DC30
Phase Inverter & Power Amp
9/11/ 2008. I. G. Morris

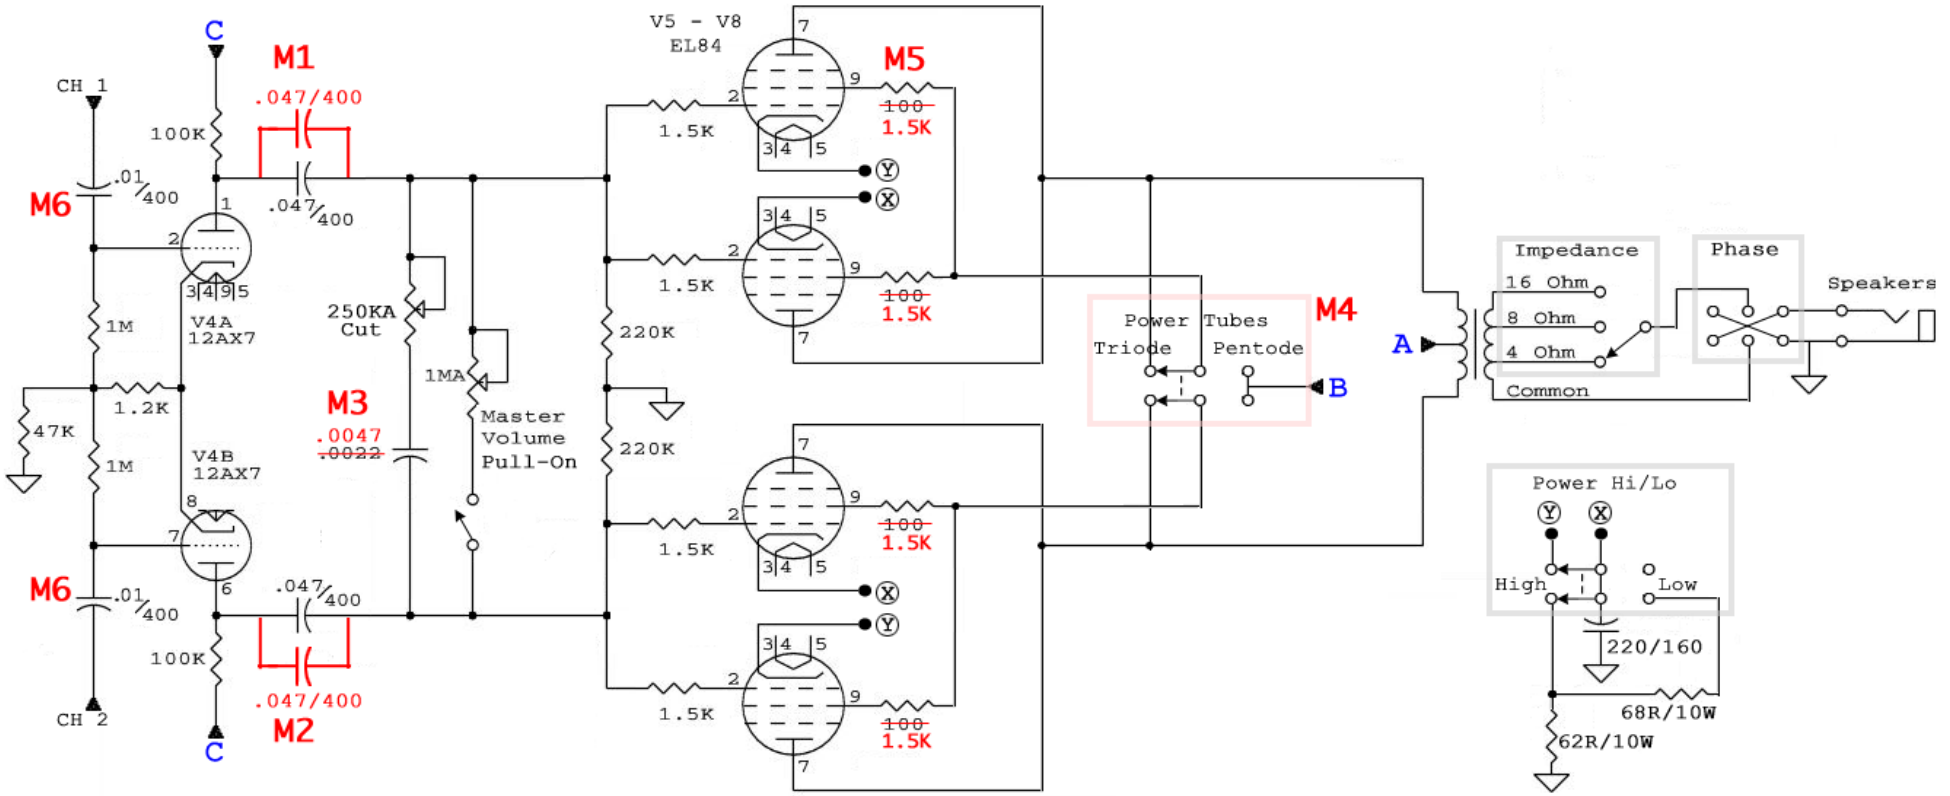
M1,M2: Added .047 coupling caps to improve bass response. 5/6/08
M3: Changed "Cut" cap to .0047uf. 5/6/08
M4: Added "Pentode/Triode" switch. 16/6/08
M5: Changed 100R screen resistors to 1.5K/1W (after K O'C). 9/11/08
M6: Substitued SOZO brand caps. 9/11/08
